559-2021 ADDENDUM 1

LINDEN LIFT AND FLOOD PUMPING STATION (LFPS) UPGRADES

ISSUED: September 13, 2021
BY: Carlos Mota
TELEPHONE NO. 204 954-6884

A9: Refer to Automation Drawing A0004 – Bill of Material Item #29

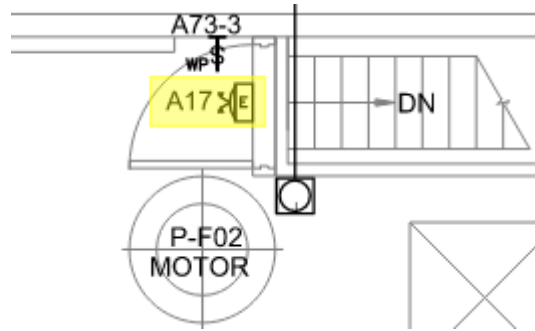
Q9: Per Schneider Rep – “*Corrected the following issues with existing client drawings: power supply / CPU in incorrect slots, unable to fit all necessary cards in 1 rack so added a rack extension, drawings call for (1) AMO0810 module (this doesn't exist) so replaced with (2) AMO0410 (for clarification should confirm with customer that 8 analog output channels is indeed what they are requesting).*” This is referenced from Drawings A0004 and A0009. Can you please confirm that we'll supply two 4pt AO cards (BMXAMO0410) or provide clarifications?

The provision of two four point analog output cards in lieu of one eight point card as specified is acceptable
